Hillingdon

Outline Fire Strategy – Rev E

OF-OFS-3671-01-E

Appendix A – Drawing Comments

3 Building 4 - Second Floor Plan
1 : 200

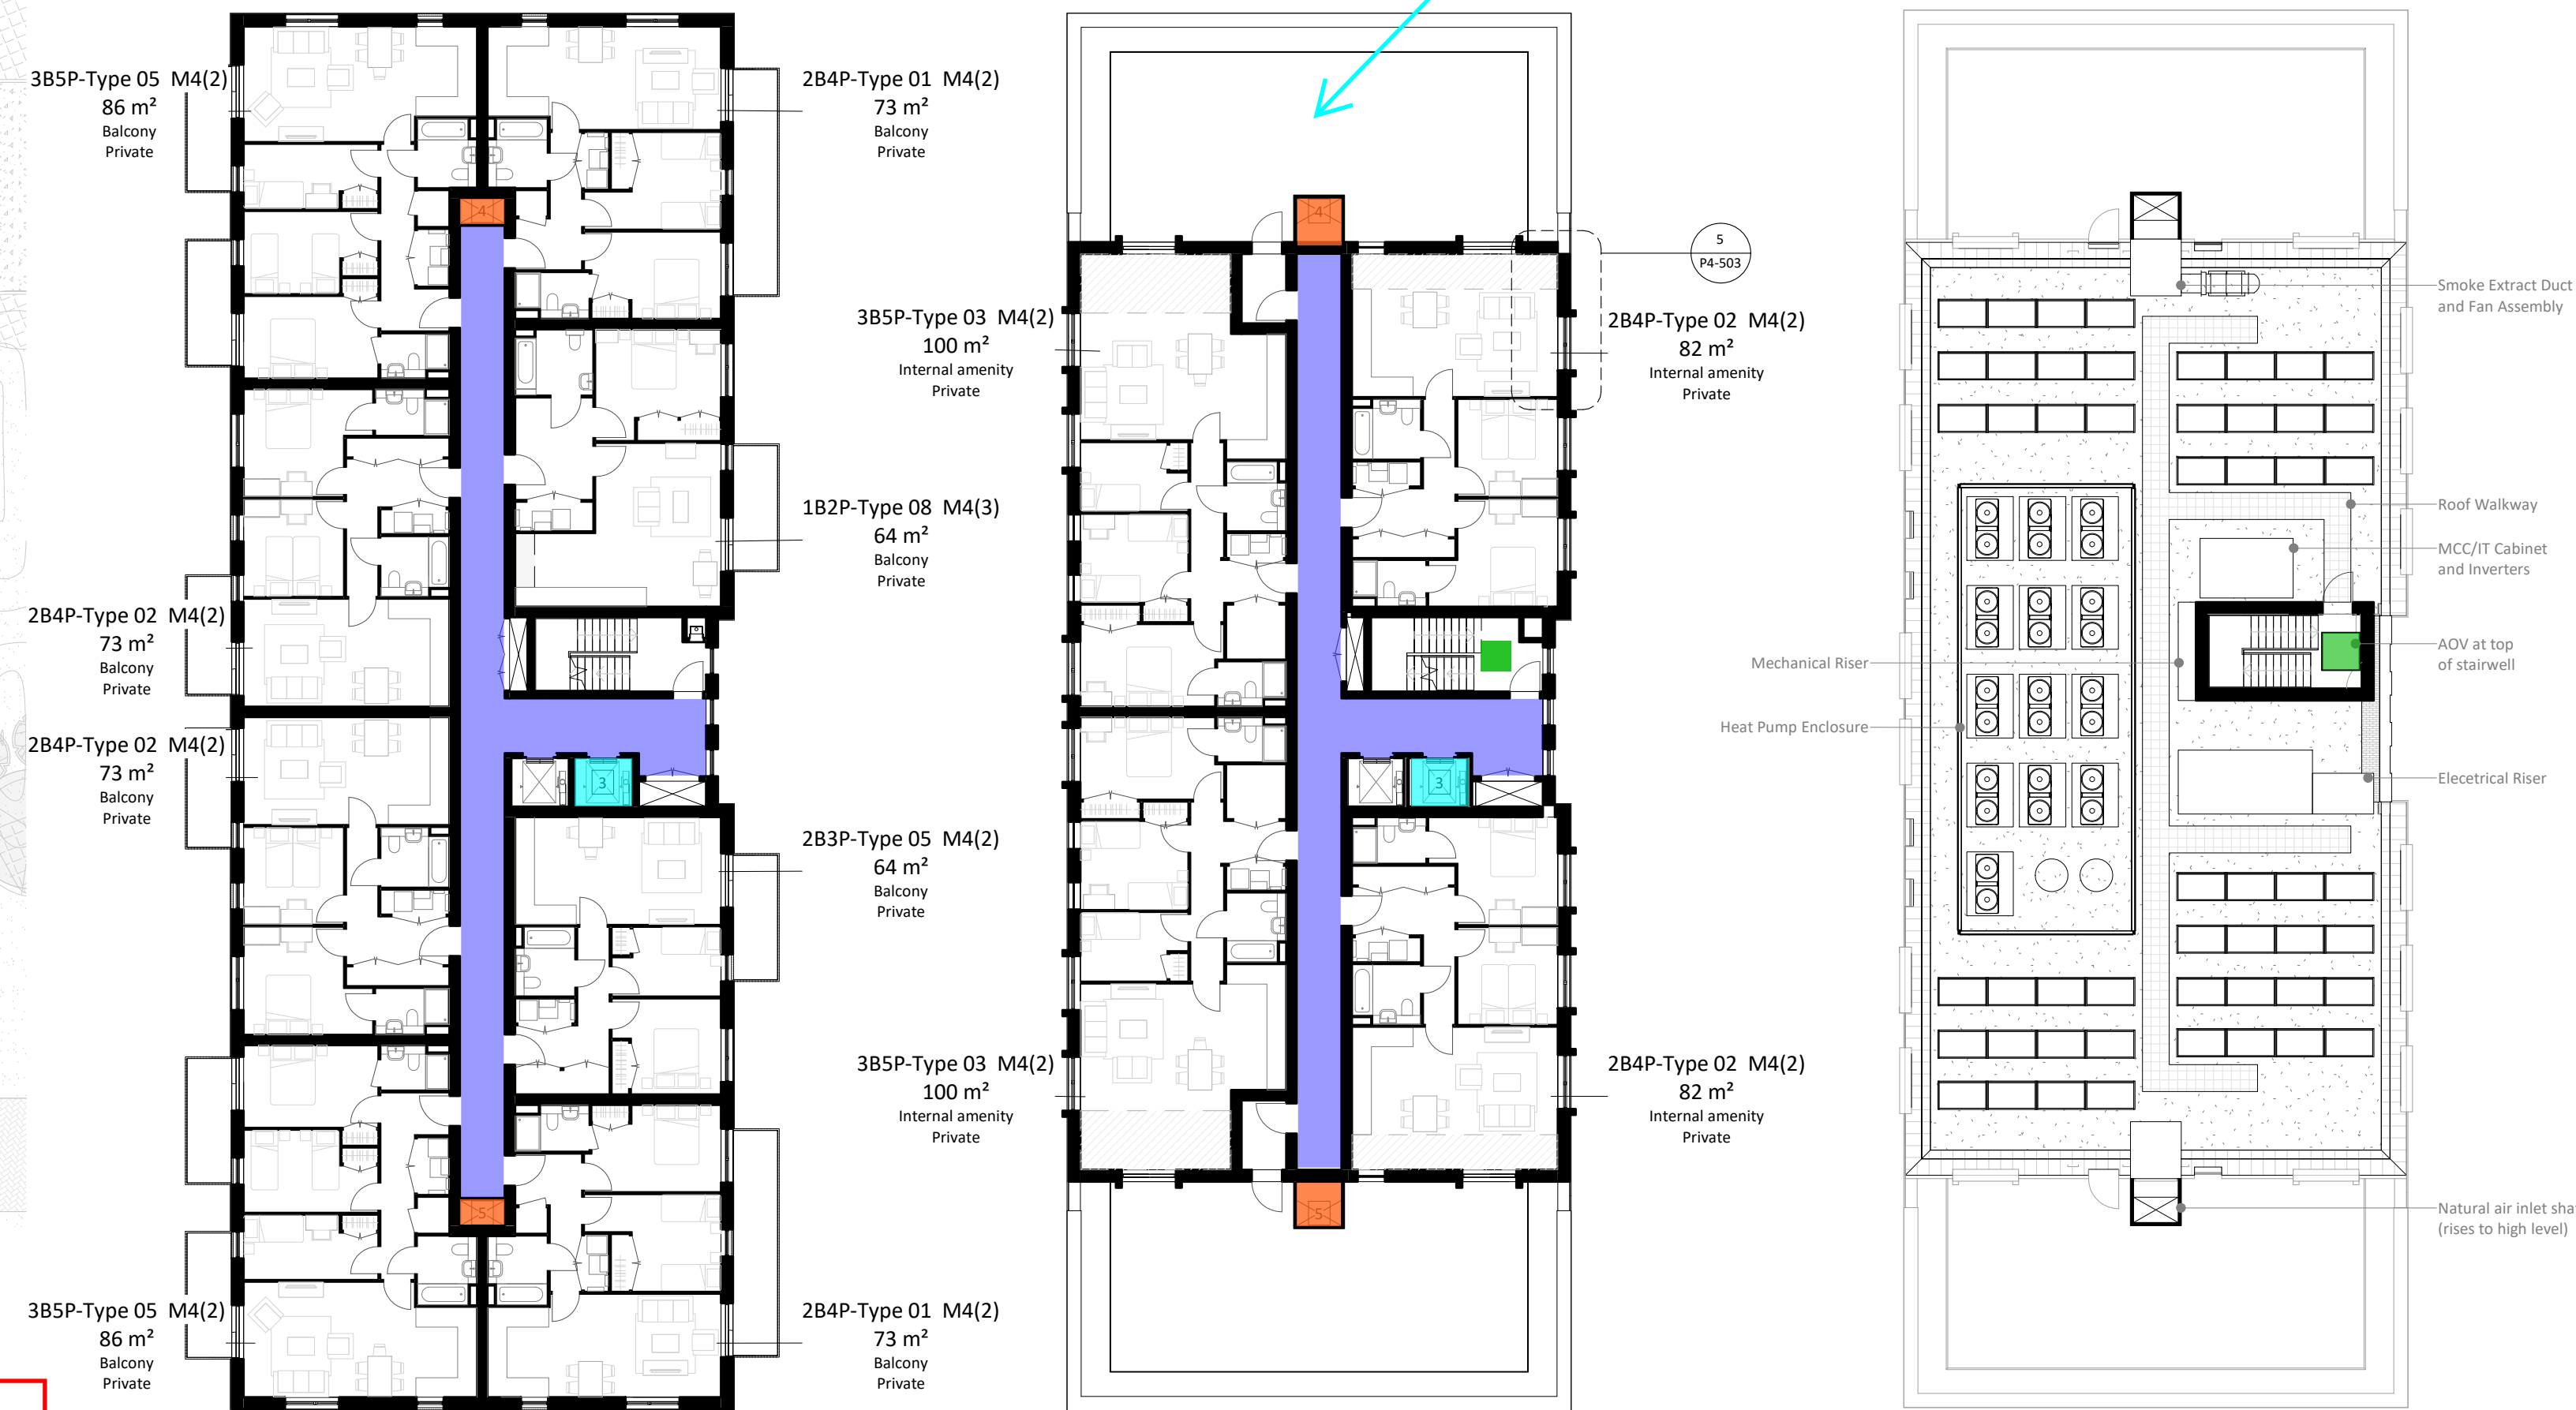
The cross-corridor doors and the lobby AOV's direct to the external are to be omitted, allowing for 2x 0.8m² mechanical smoke shafts are to be provided at the remote ends of the corridors (one at each end). CFD modelling would be required to justify this deviation. However, considering that the travel distance isn't excessive and that the apartments are not impeding the vertical escape route, it is considered that this proposed solution has limited design risk.

To be noted, the government have stated from May 2020, all new building's over 11m in height are required to be provided with sprinklers, see Section 9.

1 Building 5 - Ground Floor Plan
1 : 200

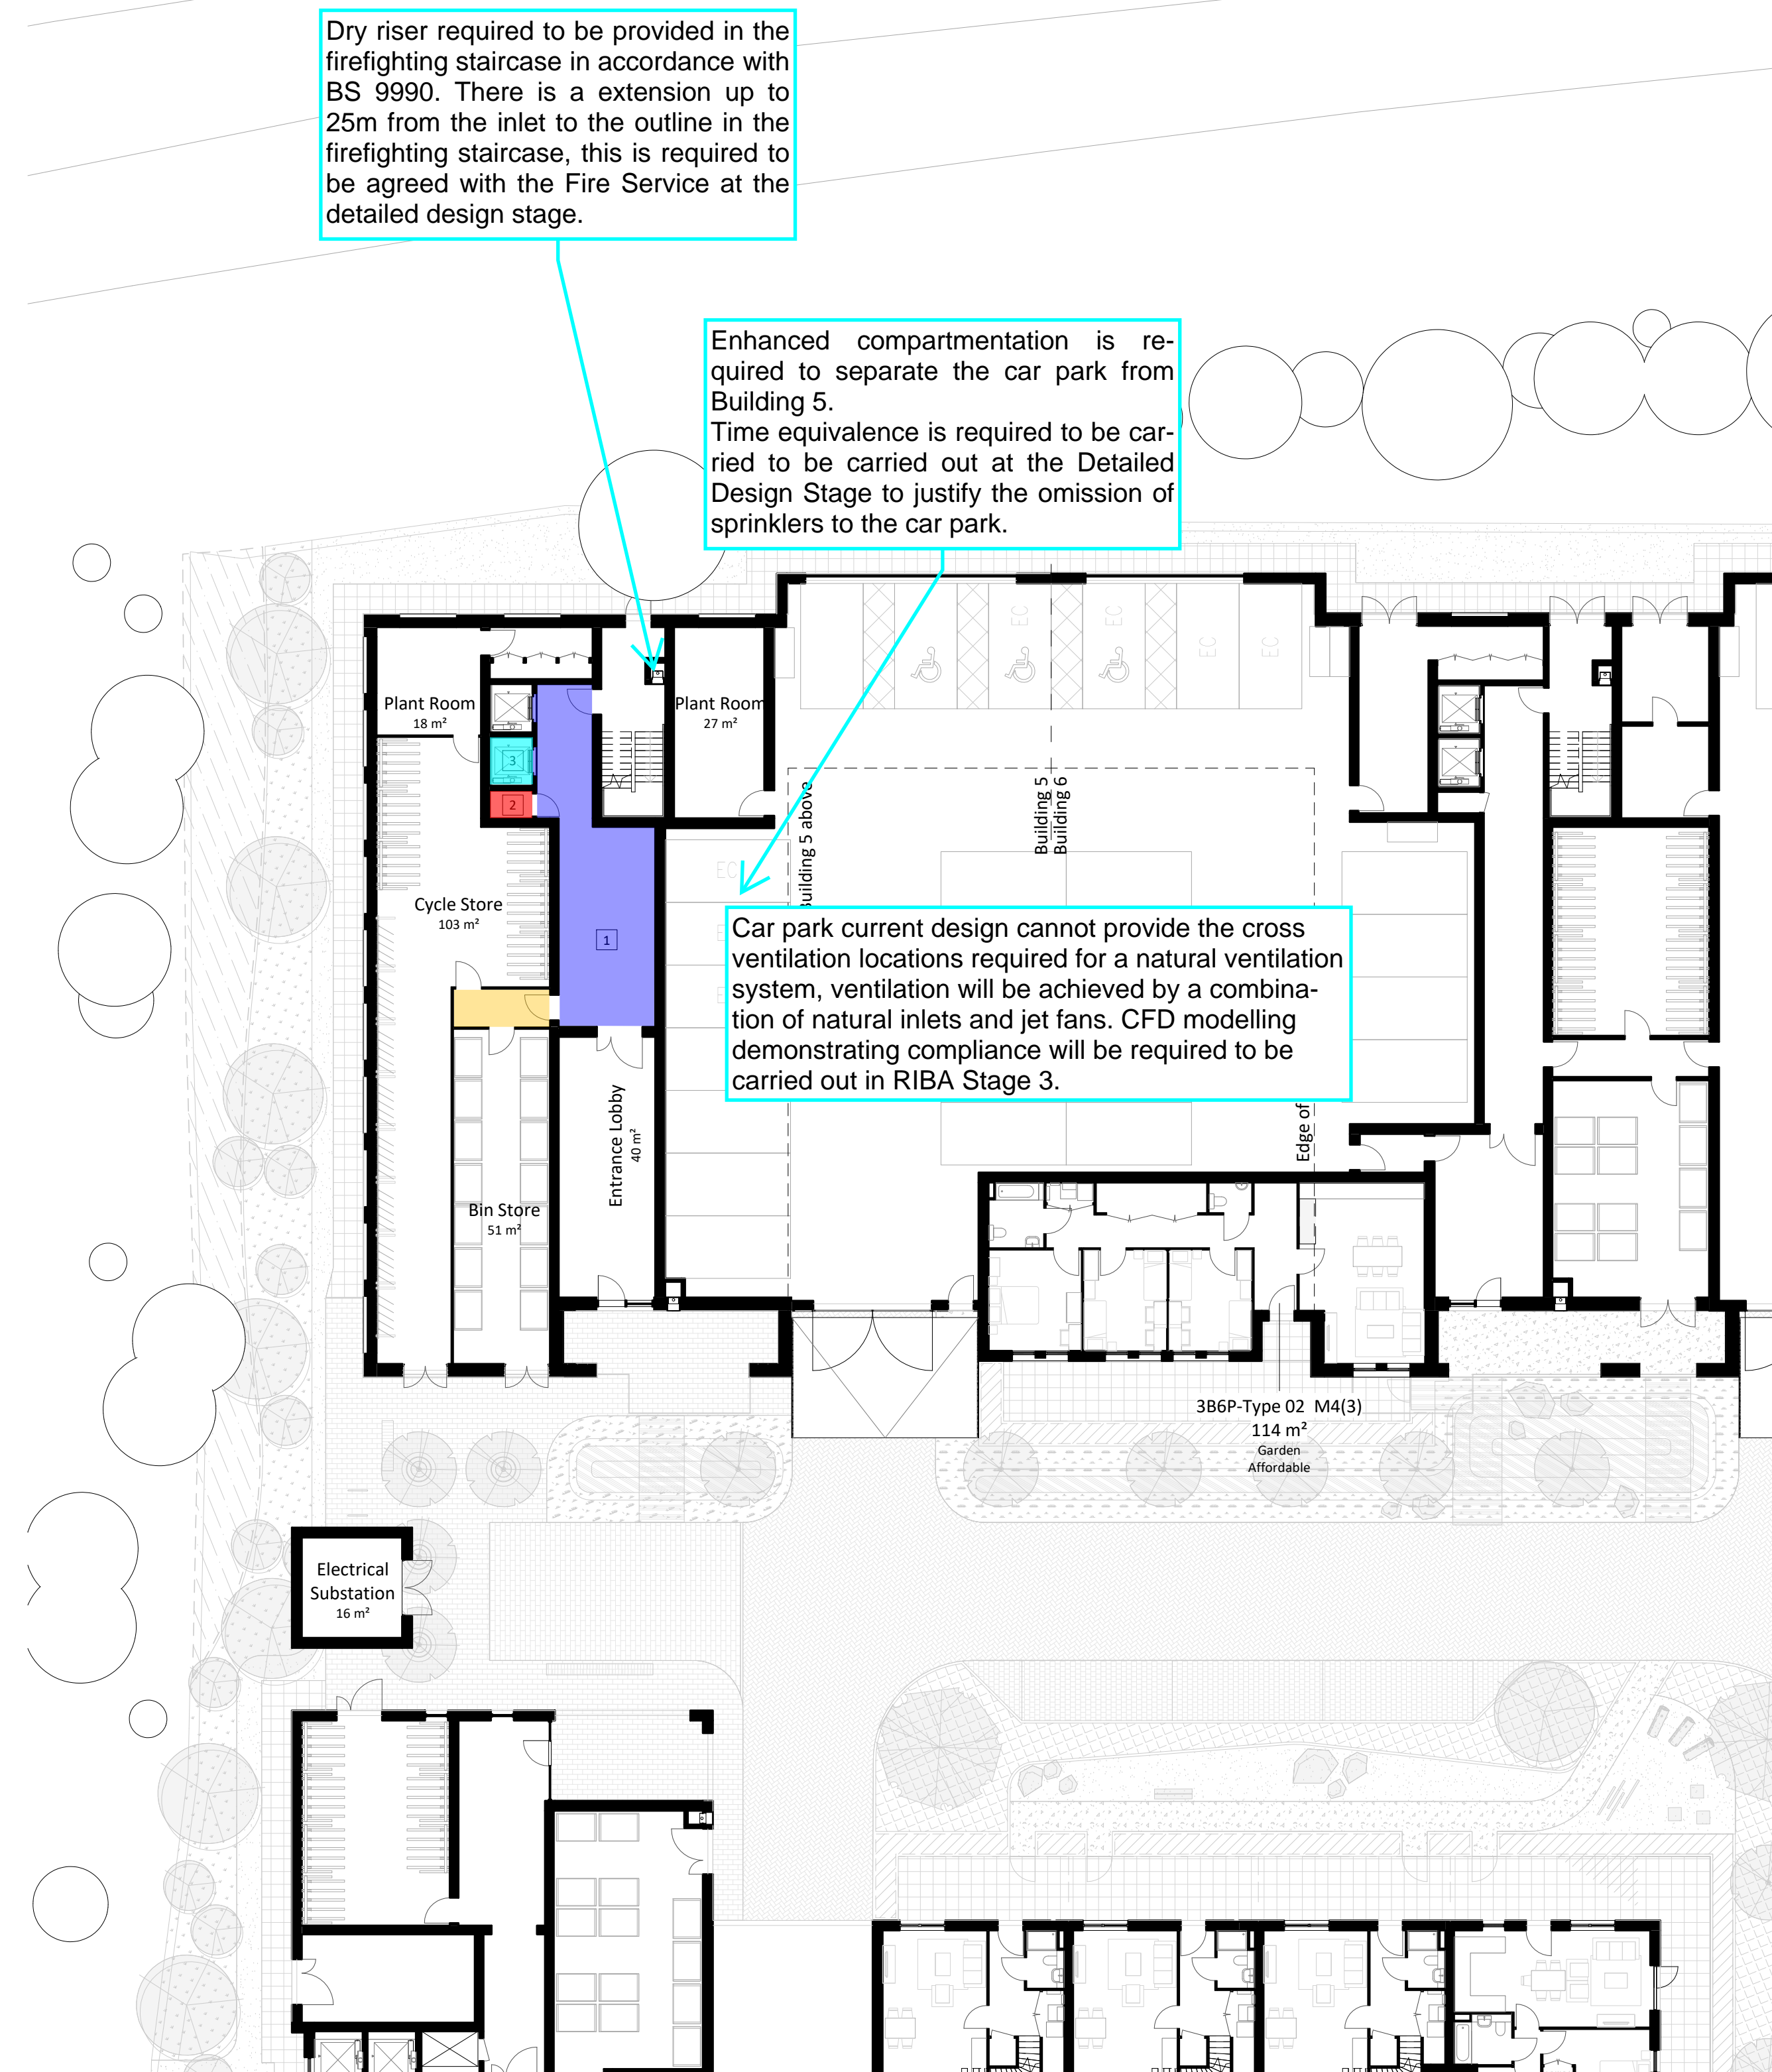
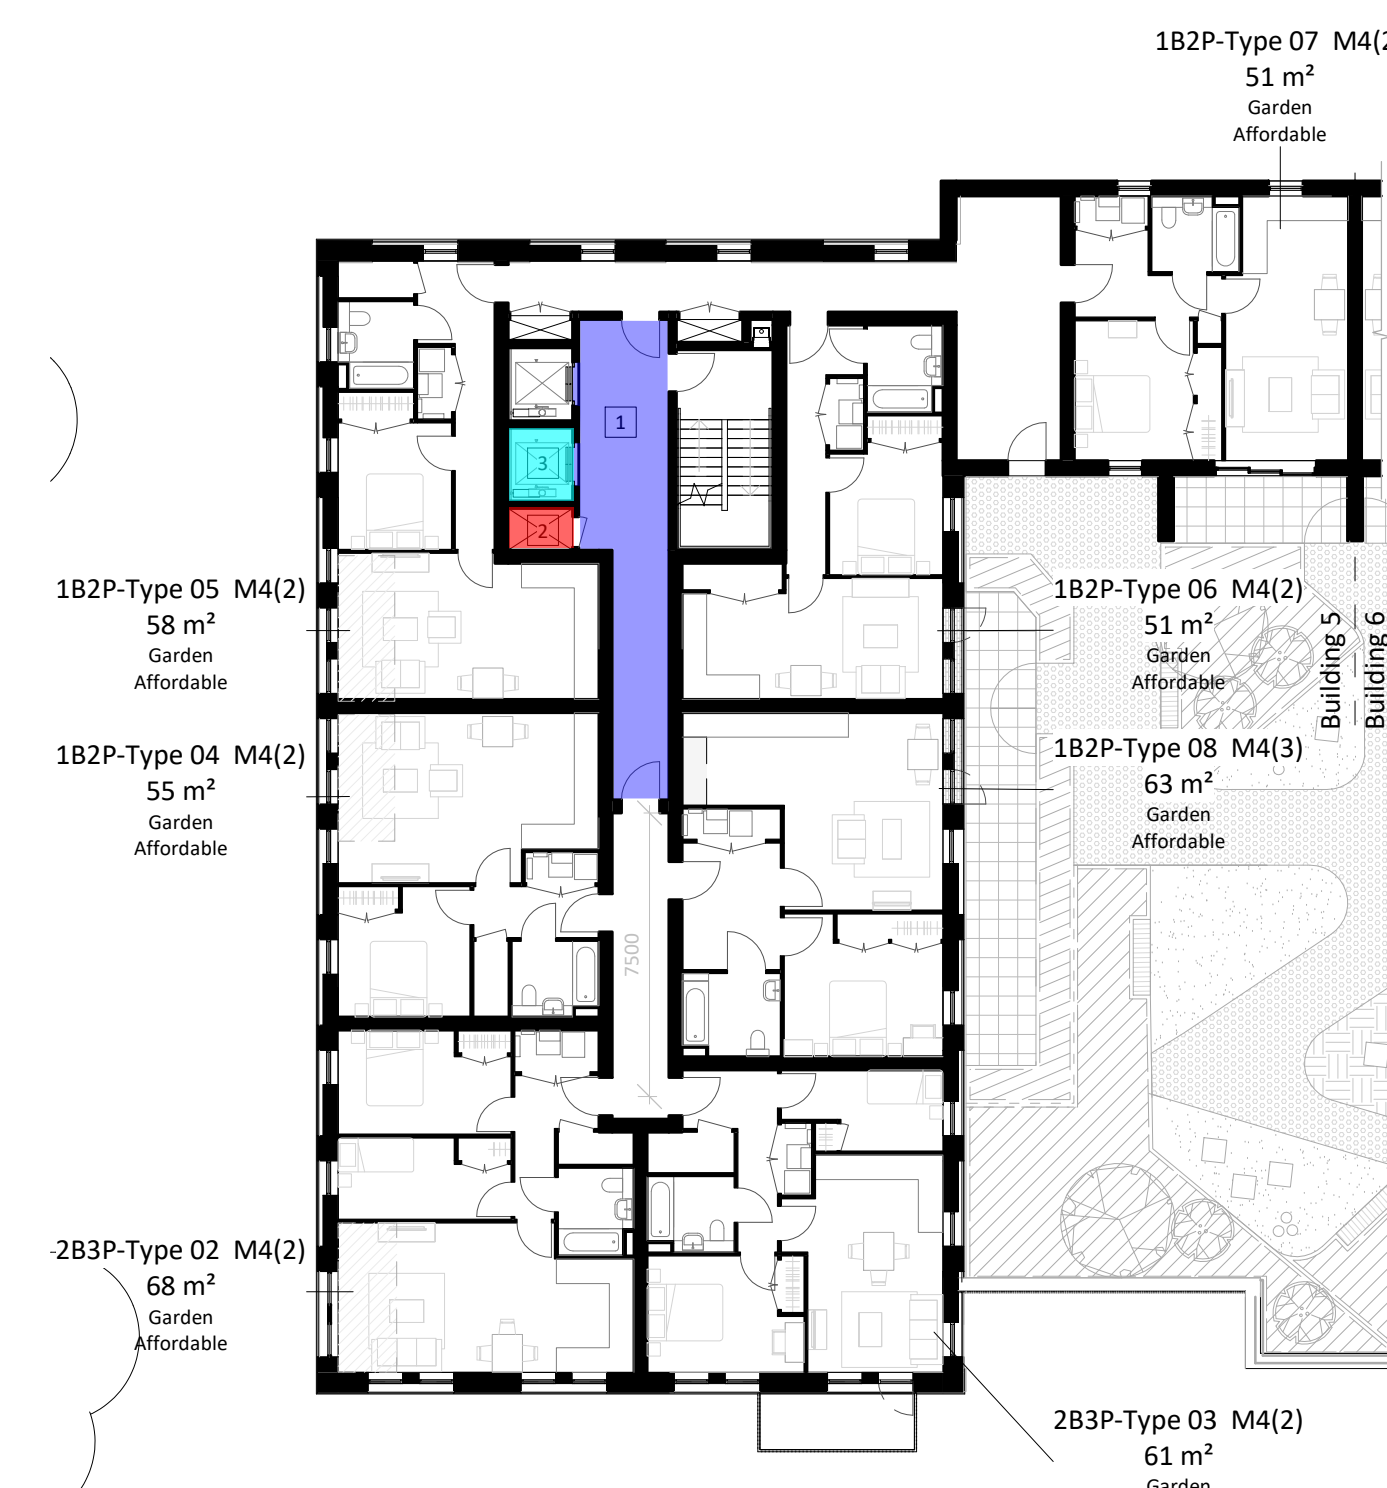
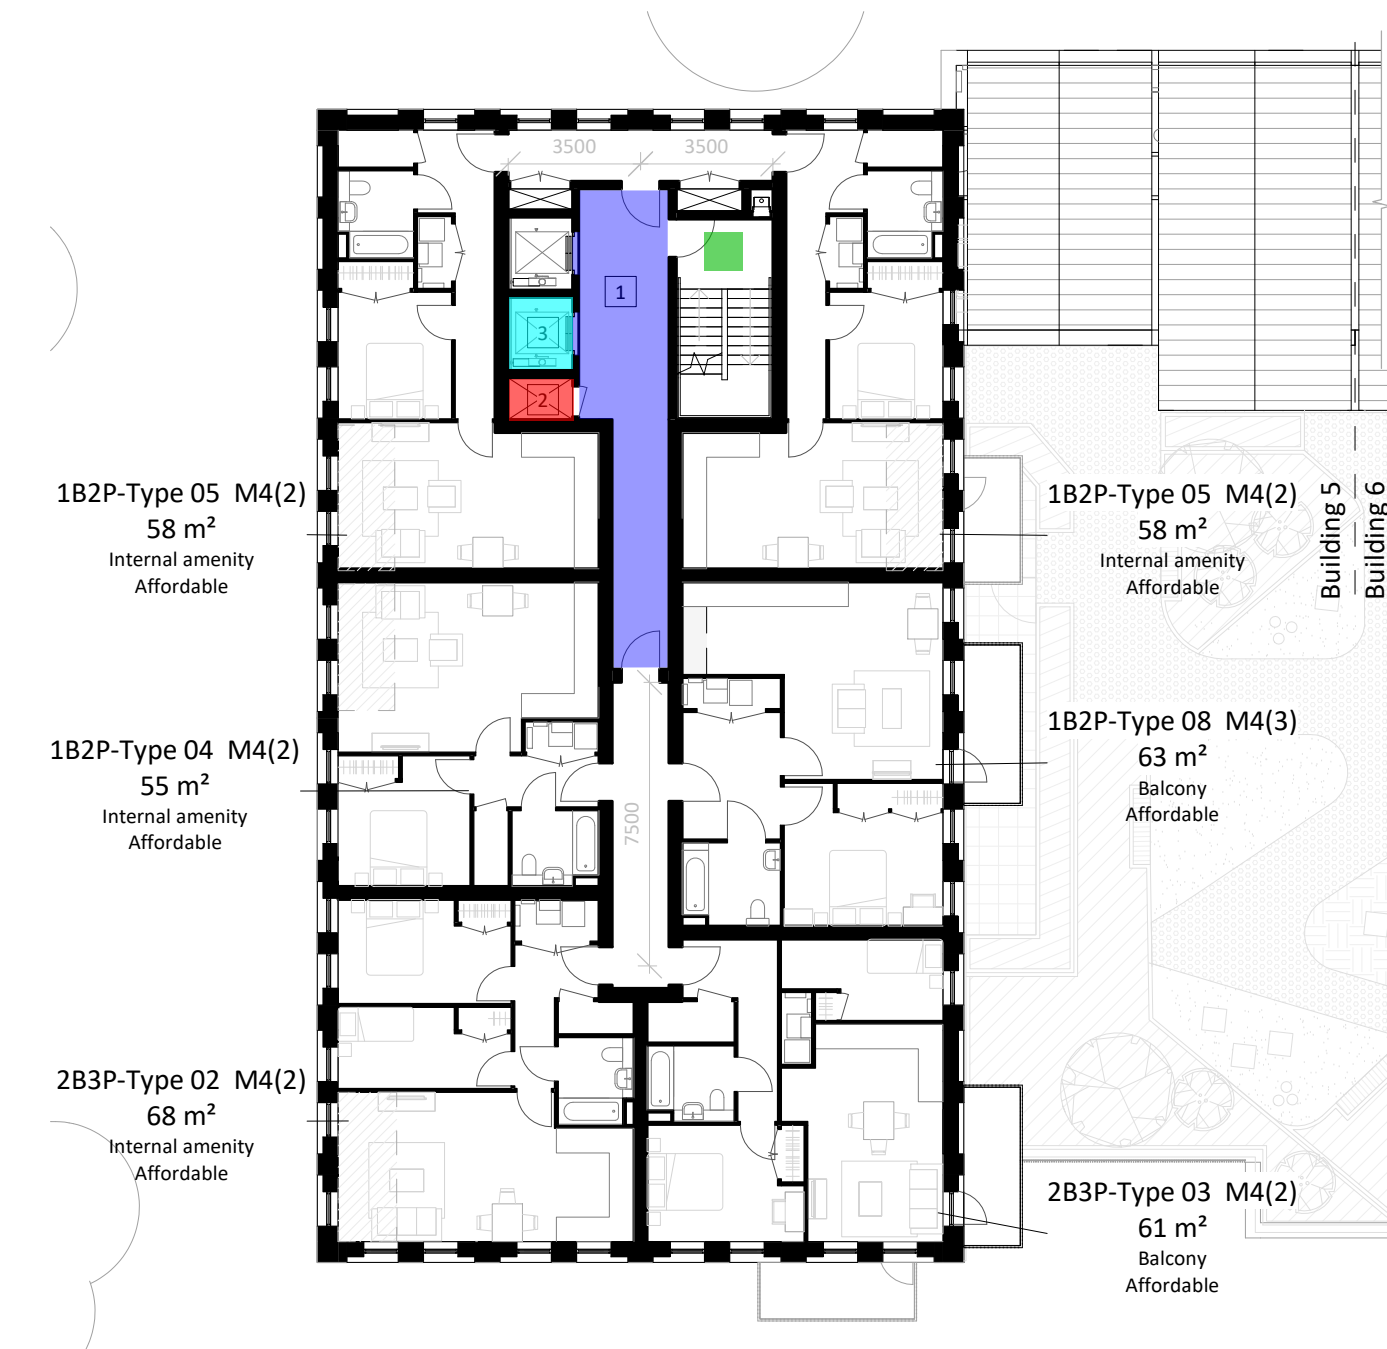
To be noted, if the service riser is to only contain water services or metal ventilation ductwork from the ground floor, it is considered a limited fire hazard. As such, this riser shaft may be located in the staircase lobby.

As Building 5 exceeds 30m in height from lowest external level to topmost occupied floor, a minimum Category 2 sprinkler system with a discharge density in accordance with Table 2 - Footnote b of BS 9251, is to be provided throughout the building.

To be noted, the government have stated from May 2020, all new building's over 11m in height are required to be provided with sprinklers, see Section 9.
